# Stage 1 Road Safety Audit

Tallaght/Clondalkin to City Centre Core Bus Corridor  
BCIDA – ACM - STY\_ZZ – 0809\_XX\_00 – RP – ZZ – 0001

Client – National Transport Authority  
Stage – Stage 1

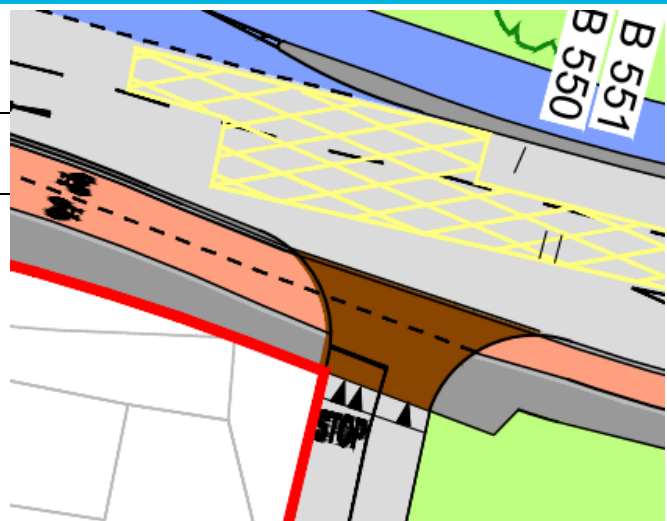
Undertake swept path analysis to ensure that all vehicle types can turn left from Greenhills Road into Mayberry Road within the carriageway extent provided and impacting on other road users.

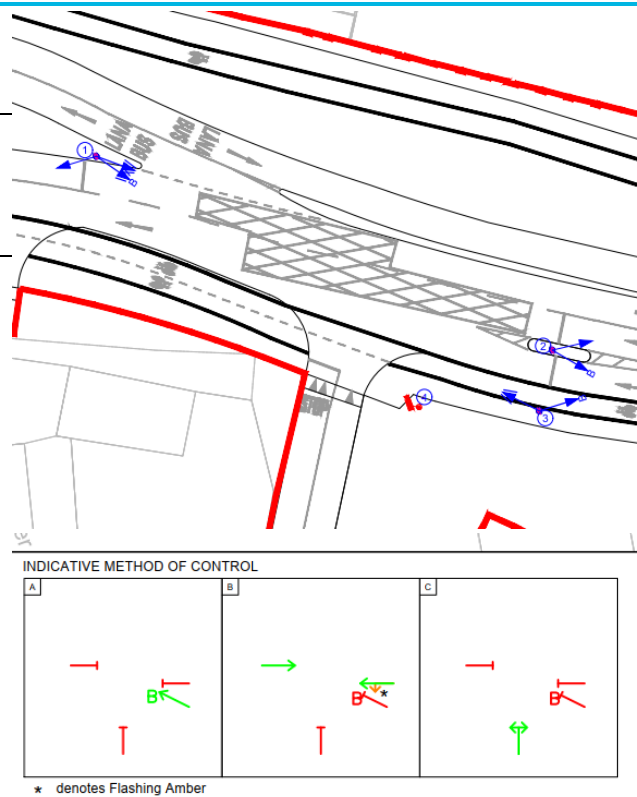
Provide clear direction to enable cyclists to continue their journey in a safe environment to minimise conflict with vehicles and pedestrians.

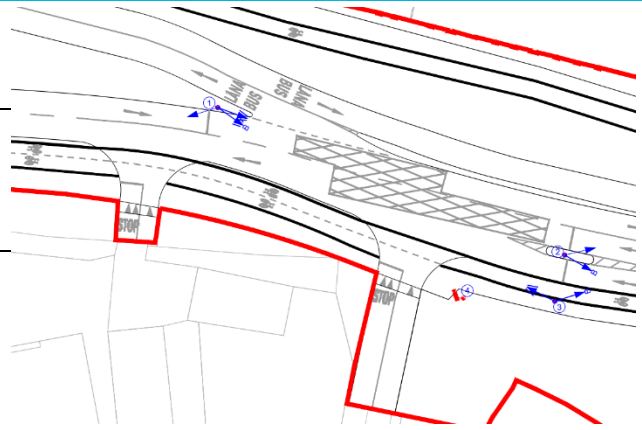
The phasing diagram for this junction indicates a 3-way signal-controlled junction, but the drawing only shows traffic signals for the general traffic and buses on the Old Greenhills Road and southbound bus lane. The road marking on Tymon Lane is indicated as a Stop. If right turning vehicles exiting Termon Lane are not held during the green phase for the southbound bus movement, this could lead to side impact collisions between this Tymon Lane traffic and buses travelling southbound.

Provide traffic signals for all arms of this junction to ensure vehicles on all arms are aware of the priority movements.

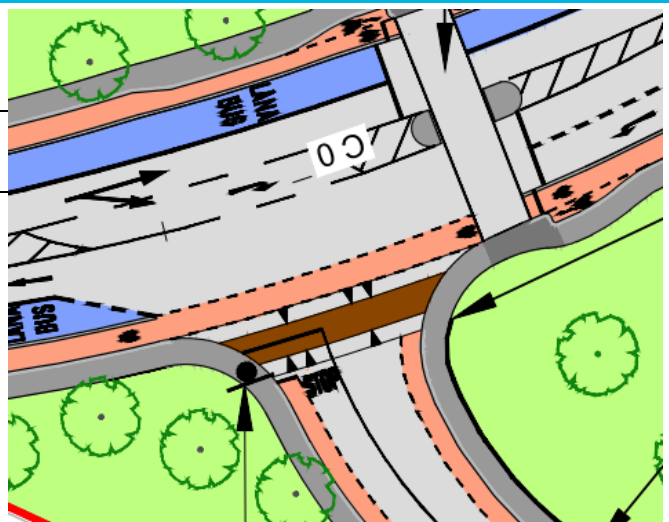
Relocate the secondary signal for the northbound traffic to the separation island between the southbound carriageway and bus lane.

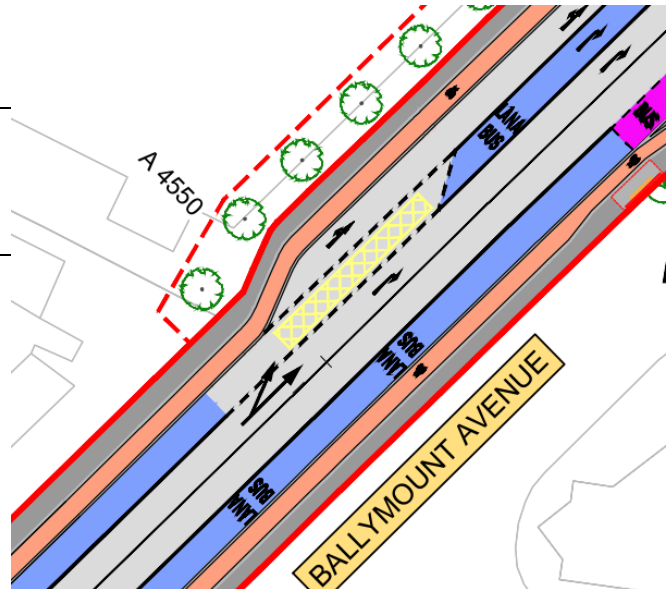
Provide clear route direction to enable cyclists to continue their journey in a safe environment to minimise conflict with vehicles and pedestrians.

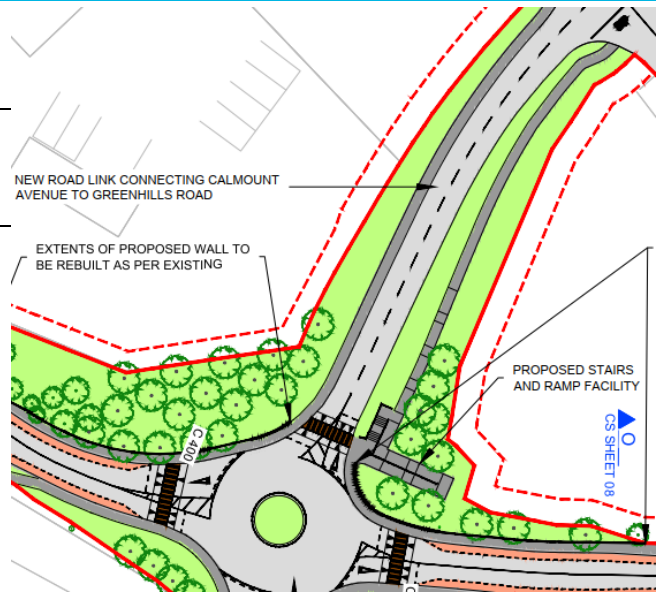
Extend the bus lane up to the yellow box hatching to allow buses to proceed to the advance bus lane at all times.

5.2.14	yes	yes		Bus lane extended	
5.2.15	yes	yes		Cycle tracks added to Calmount Avenue and roundabout redesigned as per NCM. Cycle lanes on Greenhills Road retained

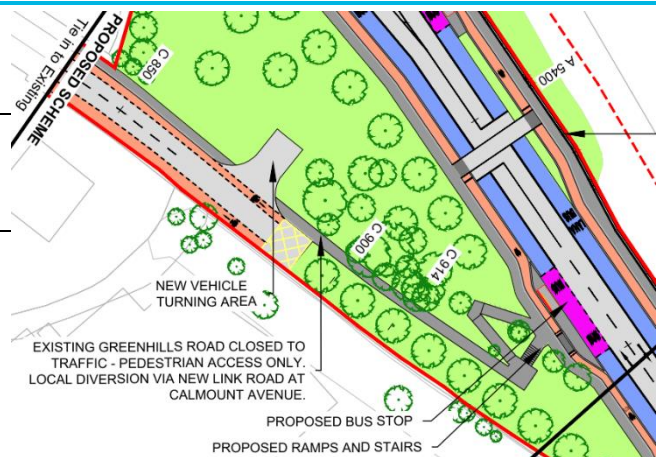
Provide adequate cycle infrastructure to remove/minimise the vehicle/cycle interaction.

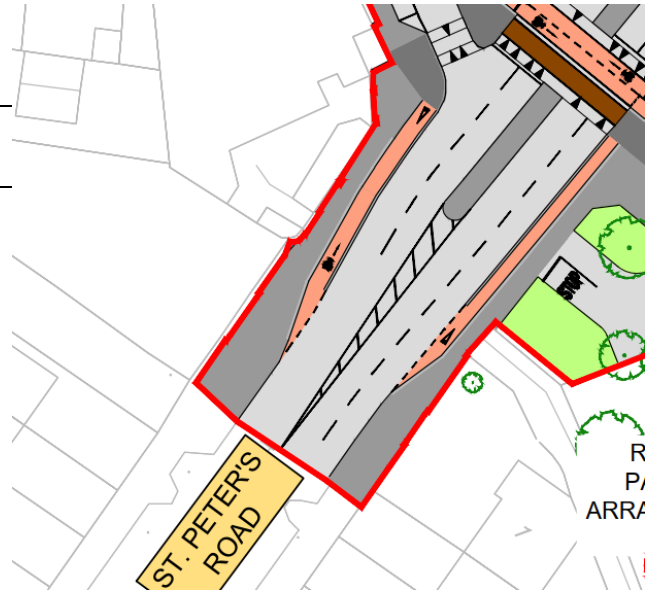
Provide adequate cycle infrastructure link the Greenhills Road to the Calmount Road extension.

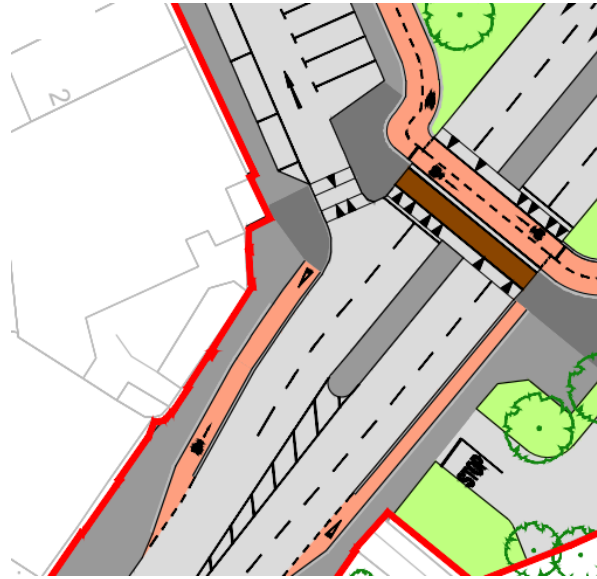
Extend the yellow box hatching back to the solid carriageway line at end of approach of Bus Lane to allow buses to proceed to the right turning offside bus lane during the red signal stage. Undertake a swept path analysis to ensure that a bus can make a smooth cross over manoeuvre through the hatching.

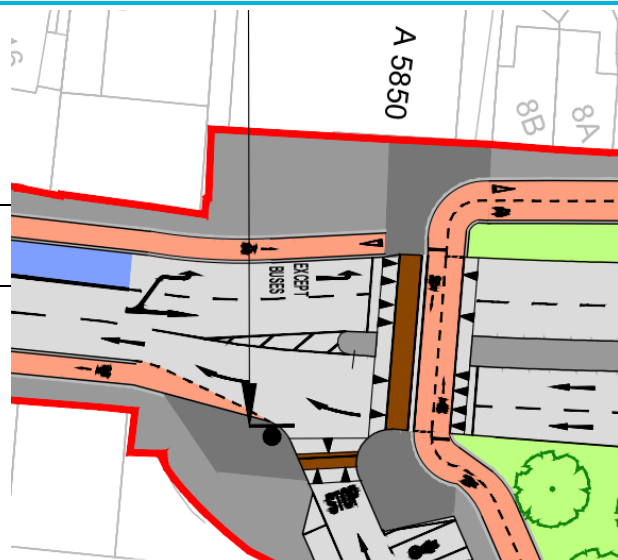
Extend the cycle track on St Peter's Road to beyond the side road fronting the Cherrytree and provide access onto the shared use area on the northern side of this link road, and a Yield linkage onto the cycle track to the rear of the perpendicular parking bays. Also ensure that this shared use area is free from street furniture.

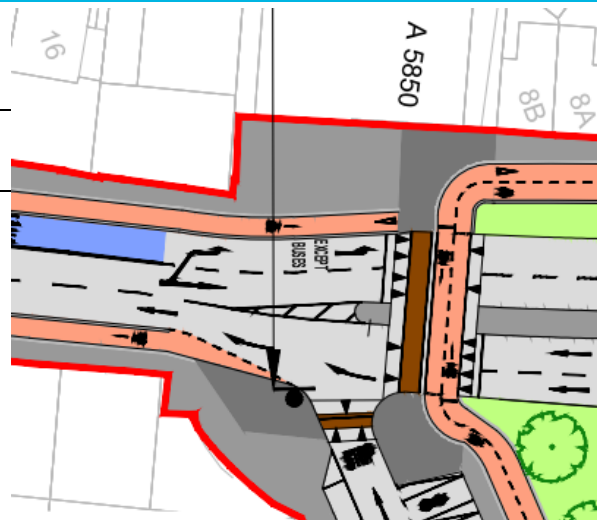
Provide a single exit lane from all arms of the Walkinstown Roundabout.

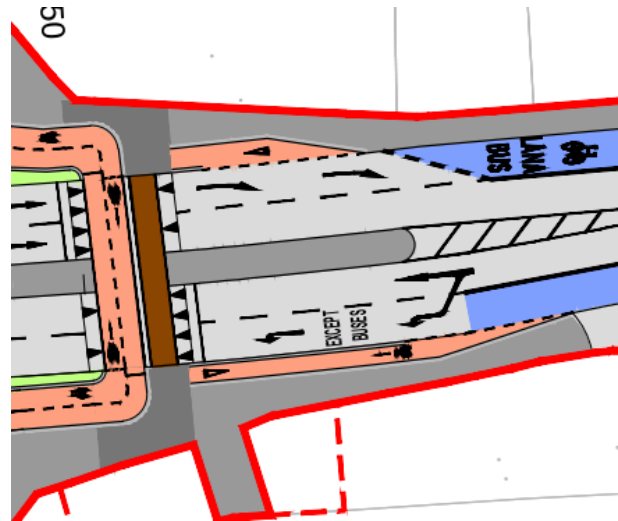
Provide clear and direct access for all cycle routes to and from the cycle tracks.

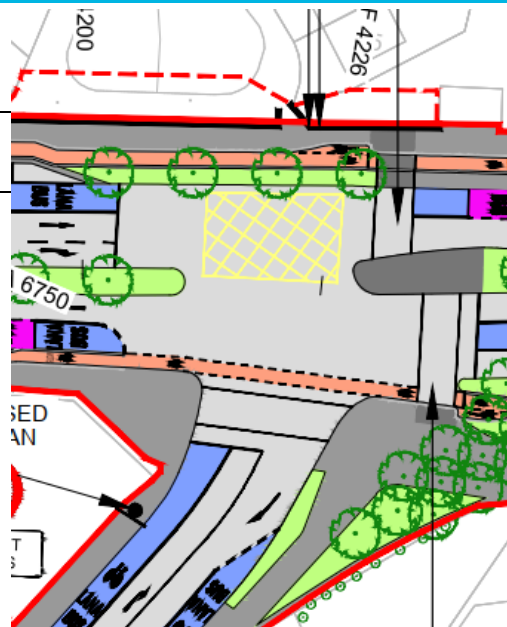
Provide the cycle merge onto the carriageway at locations where there are no vehicle merge requirements.

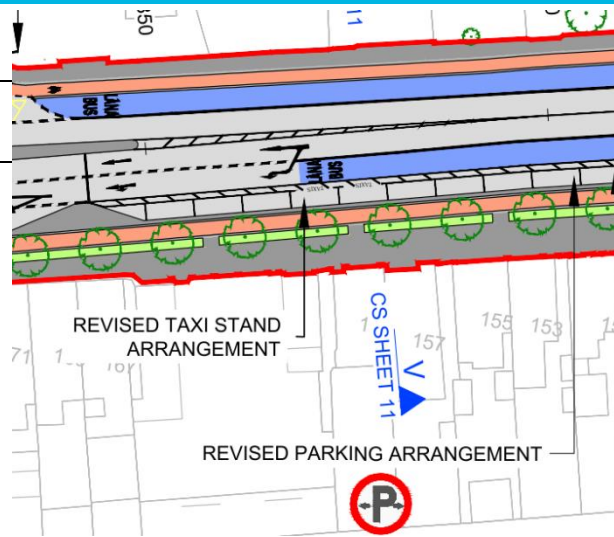
Provide traffic signals for all arms of this junction to ensure vehicles on all arms are aware of the priority movements.

5.2.23	yes	yes		All arms are signalised	
5.2.24	yes	yes		Shared use area added

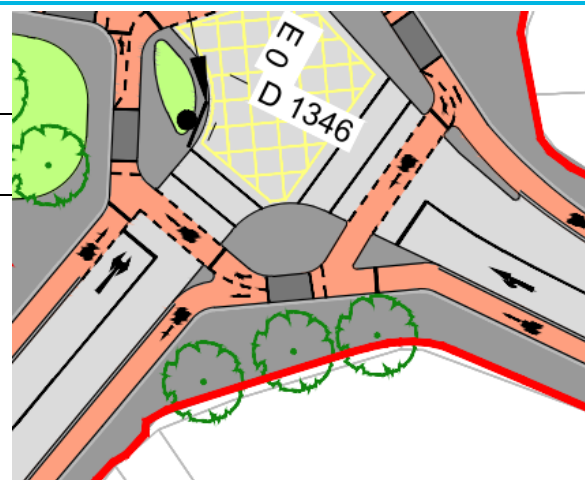
On the southern side of the Drimnagh Road, east of the Balfe Road, a revised taxi stand and parking layout are proposed. The parking is proposed to be fully parallel bays along the Drimnagh Road. The cycle lane is proposed adjacent to these parking bays, with a small separation distance between them. If taxis are picking up or delivering customers to this location, or cars are using these spaces there is nowhere for pedestrians to stand close to these vehicles. If the cycle lane remains adjacent to the vehicle parking with minimal separation to these bays this could lead to collisions between cyclists and drivers/passengers of the vehicles using these parking bays.

Relocate the cycle lane further away from the parking bays to provide standing/waiting area for pedestrians using these bays or provide a shared use area, with appropriate tactiles and signage, along this section.

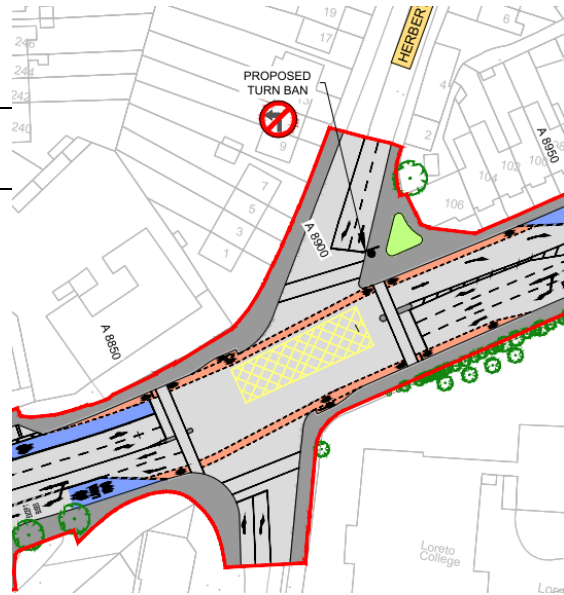
Undertake a swept path analysis to ensure that there is sufficient space large vehicles to safely turn left without overrunning the proposed kerblines.

5.2.25	yes	no		Stop line on St. Mary's Road has been altered to accommodate left turn movements from Kildare Road. Layout provided as per DMURS for Quiet Street to Quiet Street junction	
5.2.26	yes	yes		Layout amended	
5.2.27	yes	yes		RT jug pockets removed. Layout as per DCC proposals	
5.2.28	yes	yes		Junction redesigned	
5.2.29	yes	yes		Junction redesigned	
5.2.30	yes	yes		Markings amended	
5.2.31	yes	yes		Signs drawings amended to show STOP sign	
5.2.32	yes	yes		This will be addressed at detailed design stage

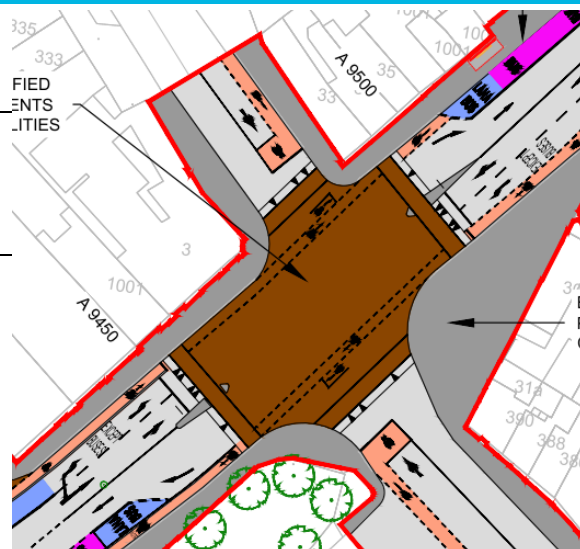
Provide clear and direct access for all cycle routes to and from the cycle lanes.

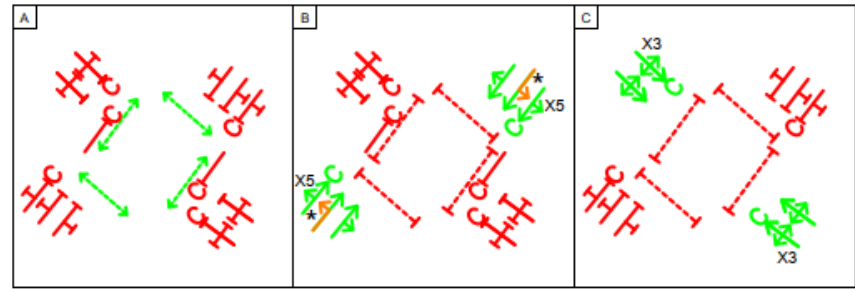
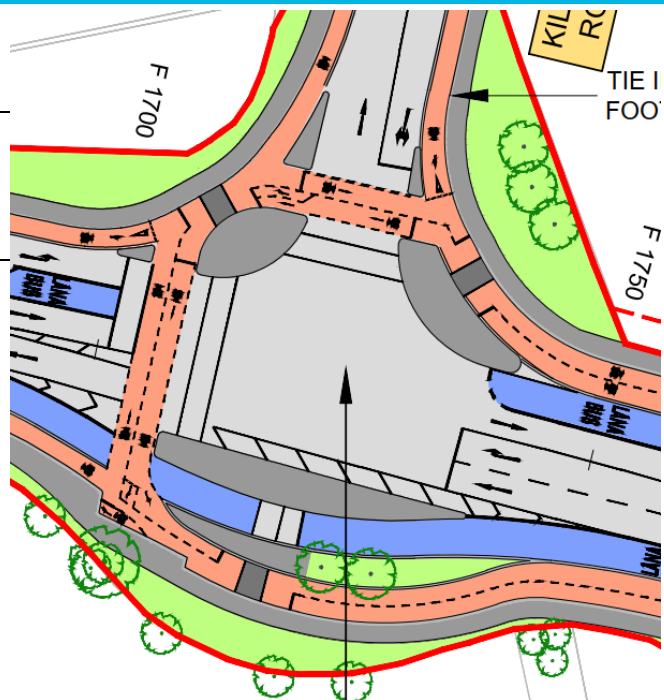
Right turning cycle pockets are provided for cyclists on the South Circular Road. These are located behind the cycle lane and in advance of the advanced stop lines (ASLs) on South Circular Road. The proposed traffic signals drawing shows this junction with 3-stage signals. Therefore, cyclists in the right turning cycle pockets or cyclists in the advanced cycle storage areas that are turning right into Dolphins Barn may conflict with opposing vehicles through this junction. This can result in cycle/vehicle collisions resulting in injury to cyclists.

Provide a safe system of control movements for cyclists through all arms of this junction.

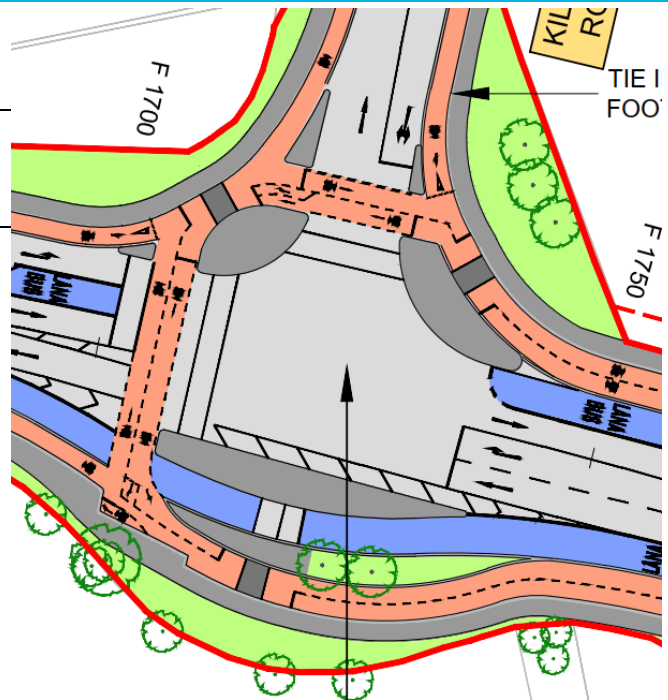
The design should ensure that sufficient green time is provided for pedestrians to cross in a single movement. Flashing amber phases should not be included as this may encourage motorists to move forward while pedestrians are still on the carriageway.

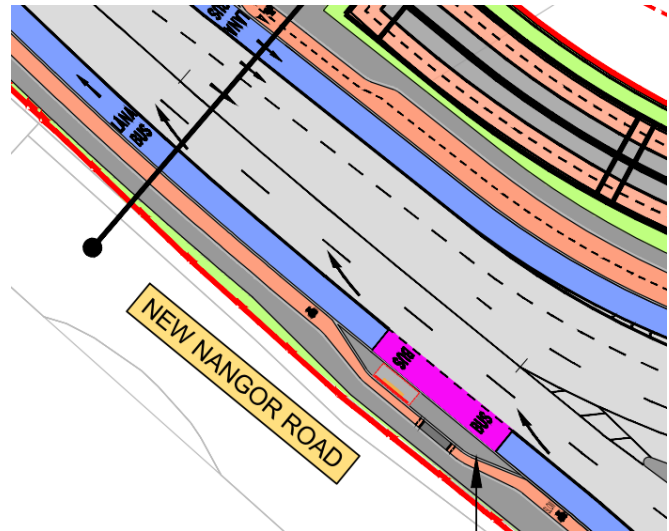
Ensure that this separation island is of sufficient width to accommodate a clear route of sufficient width for all NMUs and the required street furniture.

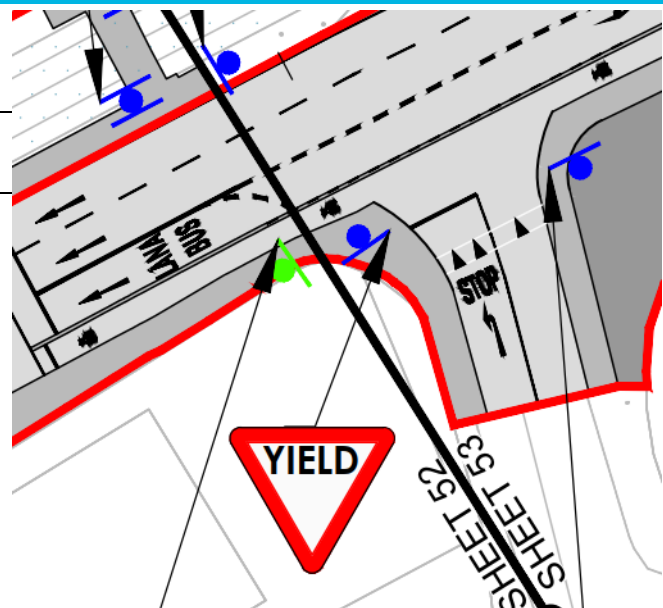
Ensure the merge markings are indicated to require Lane 2 vehicles to merge into Lane 1 at this location and provide adequate advance warning to motorists as they approach this location.

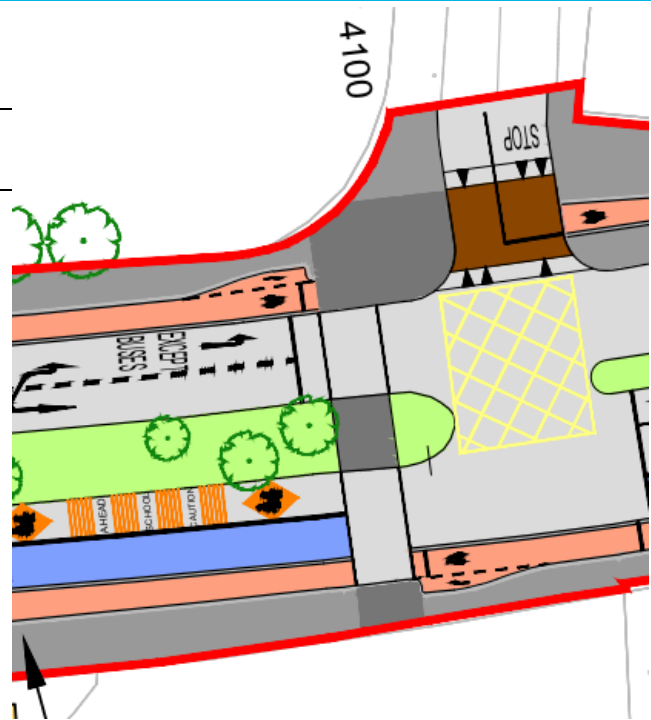
There is YIELD road sign and a STOP road marking provided at the junction between Naas Road and Robinhood Road in advance of the cycle track on Naas Road. This signage is conflicting to motorists. Failure to provide clear consistent warning signage for traffic departing Robinhood Road may cause confusion at the junction and may result in collisions between motorists and cyclists.

Provide consistent signage on the minor arm of the Robinhood Road / Naas Road junction.
